Subject: DA2021/1408 - Northern Beaches Planning Panel

SUBMISSION TO NORTHERN BEACHES LOCAL PLANNING PANEL MEETING 16 MARCH 2022 REGARDING AGENDA ITEM 4.3 DA2021/1408, 16 ADDISON ROAD MANLY

12 Addison Road

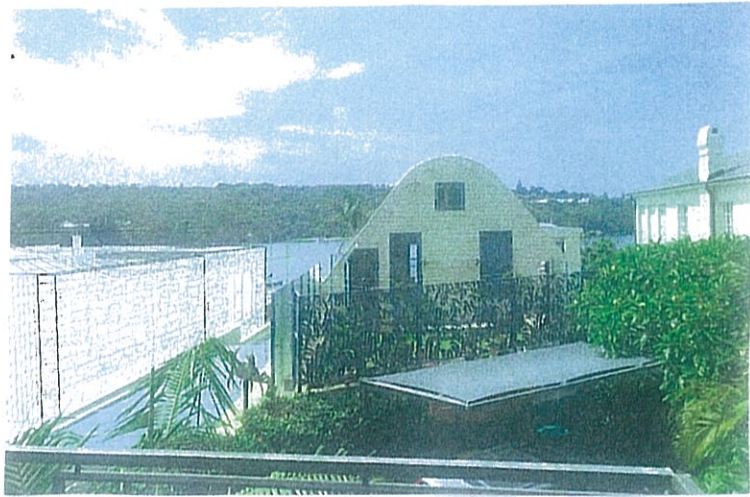
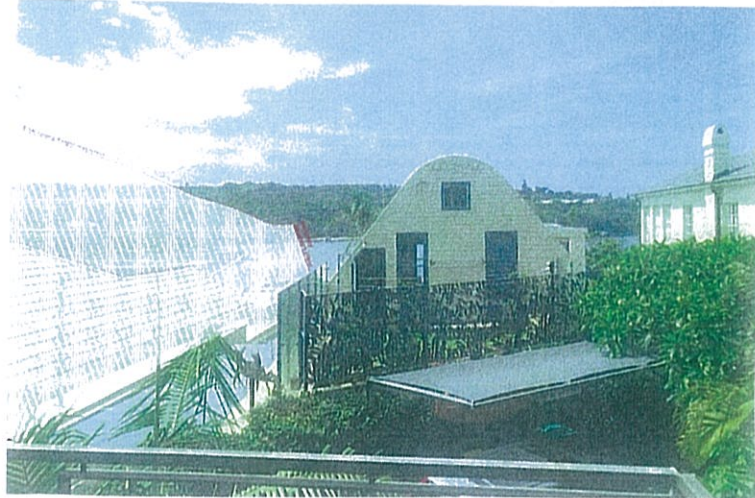
12 Addison Road – the only view from this property is from a first-floor bedroom and adjoining balcony across a side boundary. Part 3.4.3 of the Manly DCP 2013 states that the “DA assessment is to determine the extent of, and impact on views at eye height in a standing position (eye height is 1.6m above floor level) from **within the main living areas (and associated terraces/balconies)...**”. The proposal has no impact on views from the ground floor living areas of 12 Addison Road as there are no views of Little Manly Cove available from this level. From the view sharing objective under 3.4.3 of the DCP and in the context of the *Tenacity* planning principles the impact on the view from the first-floor bedroom/balcony of No.12 is satisfied in that approximately 65% of the current view of Little Manly Cove are retained, including the land/water interface, as evident at *Figure 1* attached. Similarly, a compliant development would result in an increase in view loss as evident at *Figure 2* attached. The view sharing outcomes for No. 12 are reasonable in the context of the *Tenacity* principles and the Manly DCP.

18 Addison Road

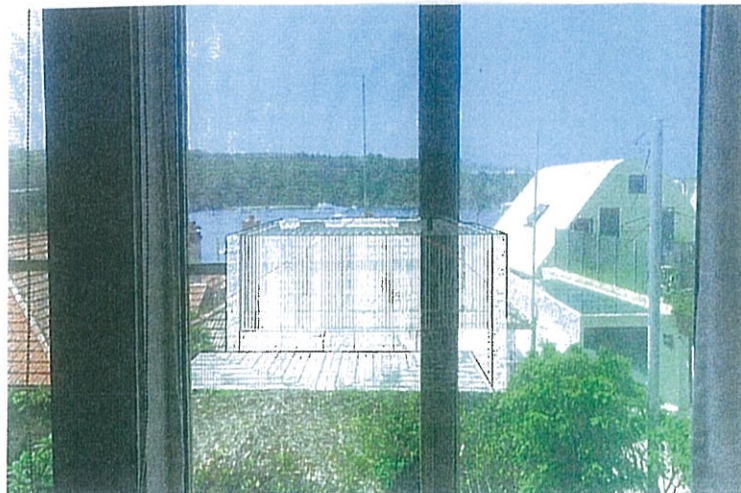
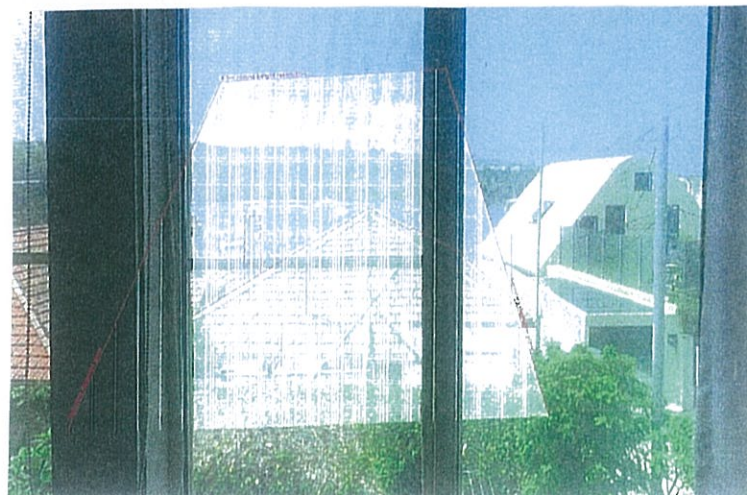
18 Addison Road – the views are from a first-floor sunroom/study over the existing single storey dwelling on the subject site. There are no views from the ground floor living areas. The proposed development will increase the views of Little Manly Cove and introduce the land/water interface with Little Manly Point through a flat roof form and reduction in the building height as evident in *Figure 3 attached*. A development fully compliant with the planning controls, that is a 2-storey component on the footprint of the existing dwelling, would result in a 100% loss of views over the subject site, as indicated on *Figure 4*, although views to the north-east to Little Manly Beach are maintained. For these reasons it is my view that the impact on No.18 would be minor in the context of the *Tenacity* principle and the provisions in the Manly DCP.
